CITY OF ALBUQUERQUE

RE: **McDonalds – Coors and Hanover**
1501 Coors Blvd NW
Grading Plan Engineer's Stamp Date: 4/5/17
Hydrology File: J11D037

Based on the information provided in your submittal received 6/15/17, the Grading Plan is re-approved for Building Permit, Grading Permit, and Paving Permit.

GRADING PLAN
C7.0

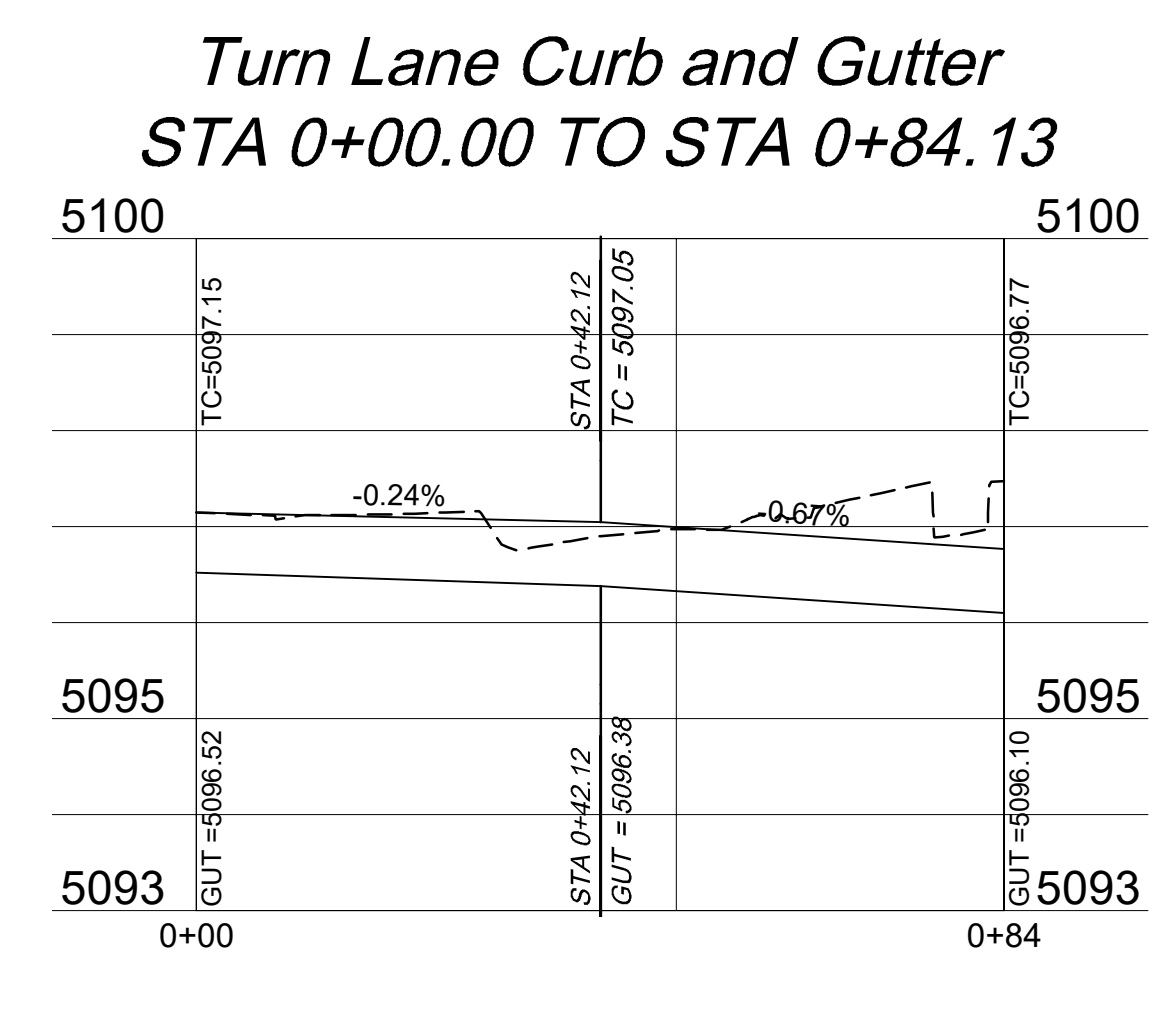
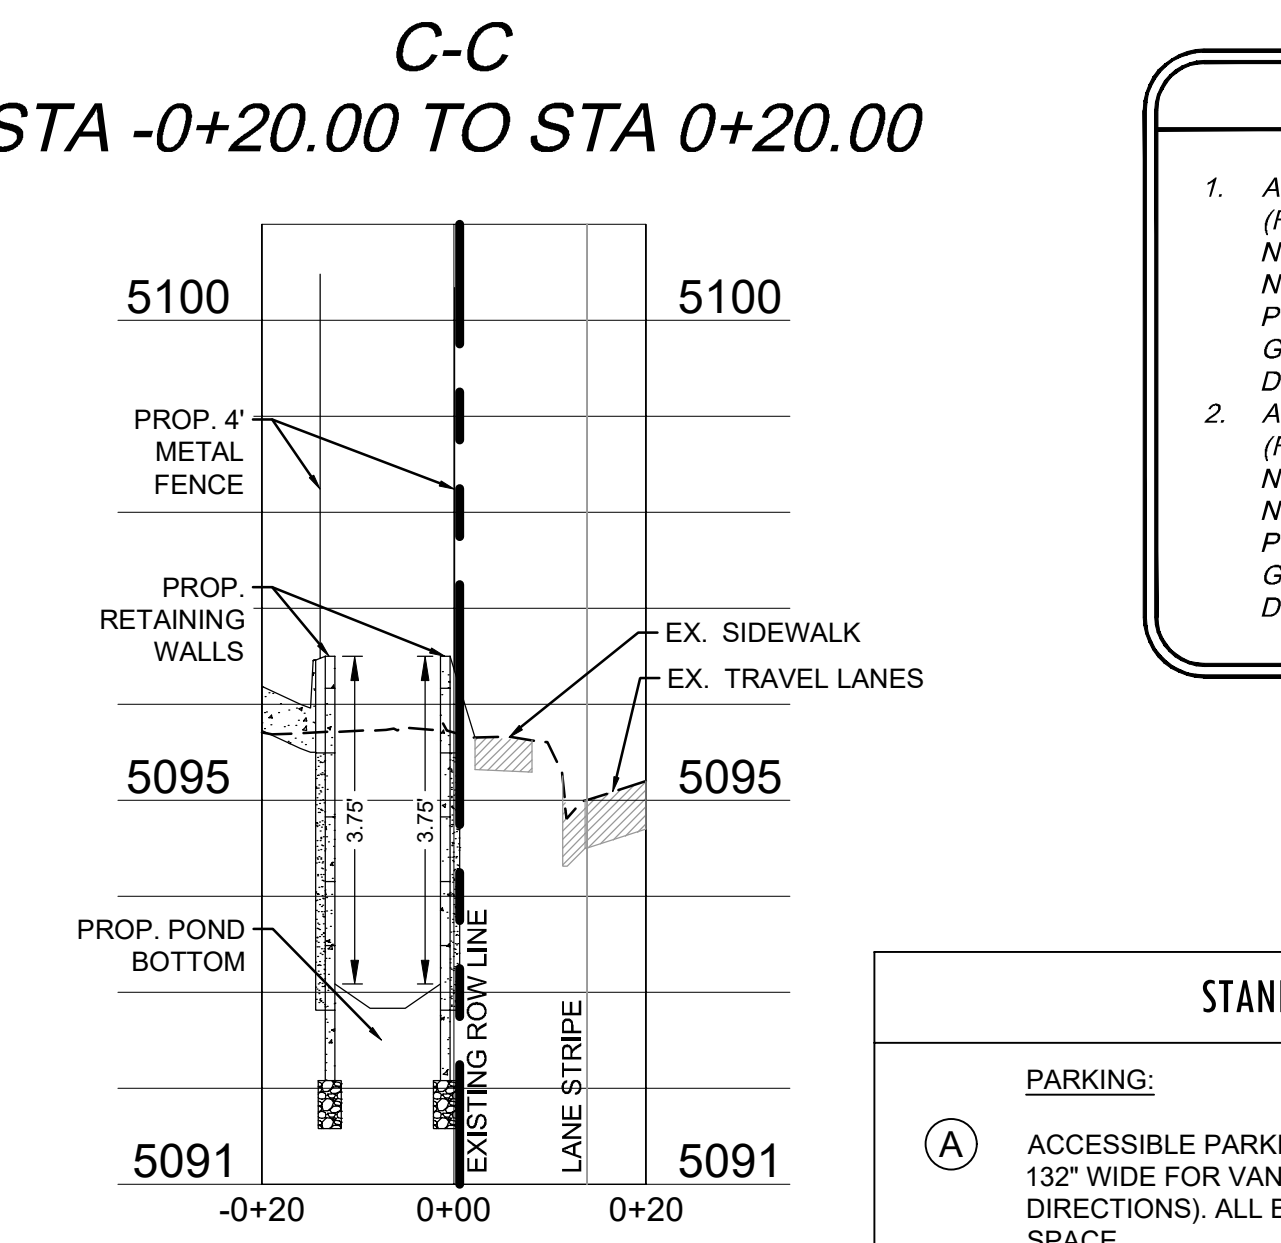
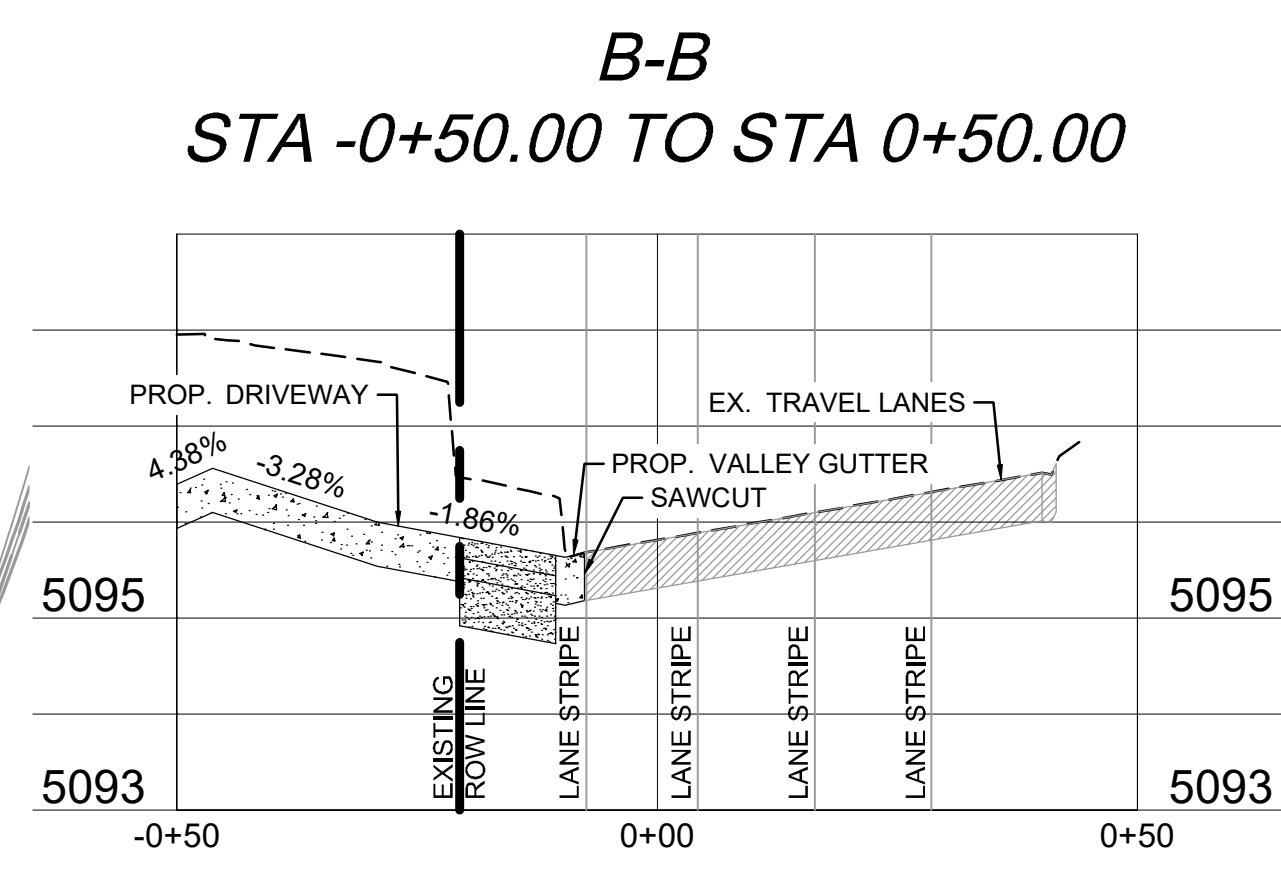
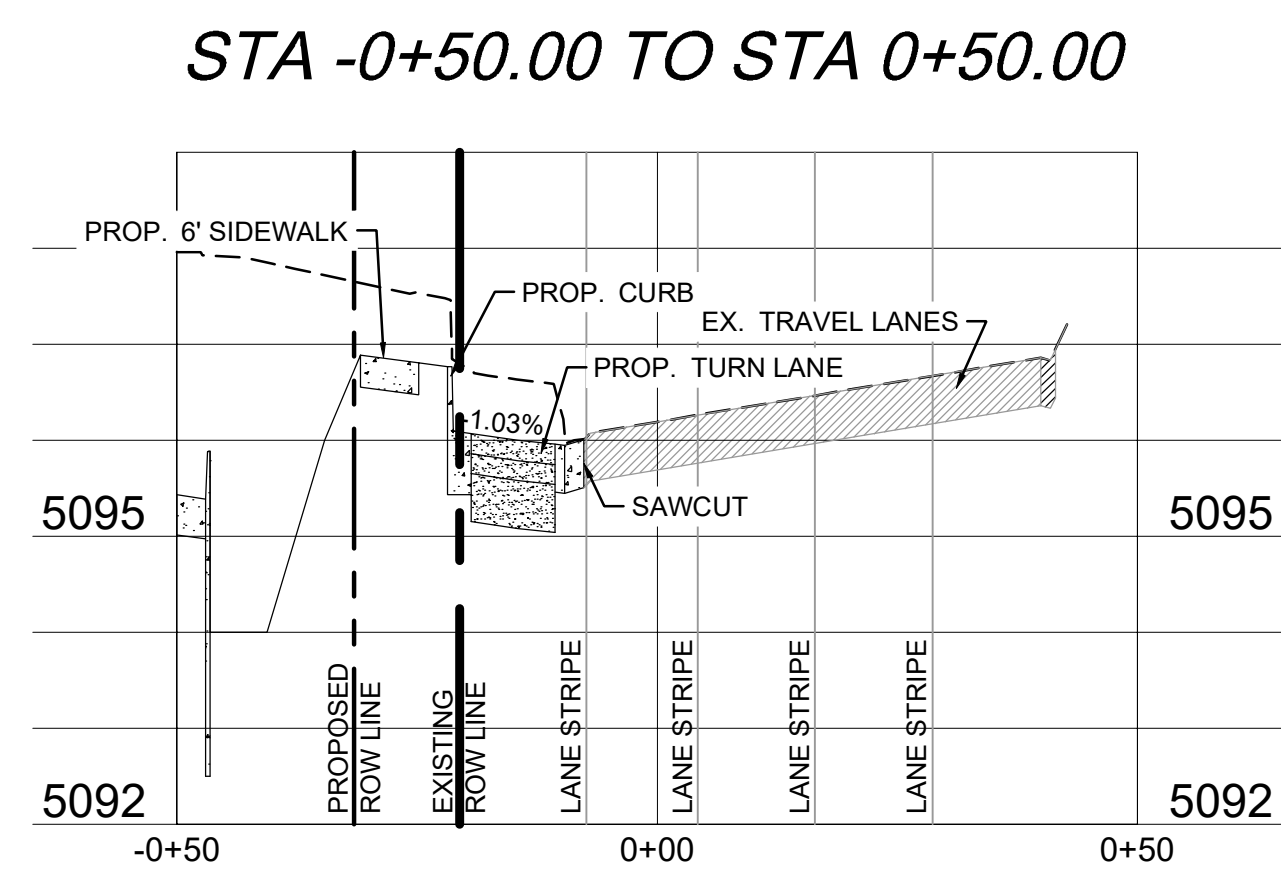
Prior to Certificate of Occupancy (C.O), a Private Facility Drainage Covenant will be required for the pond areas.
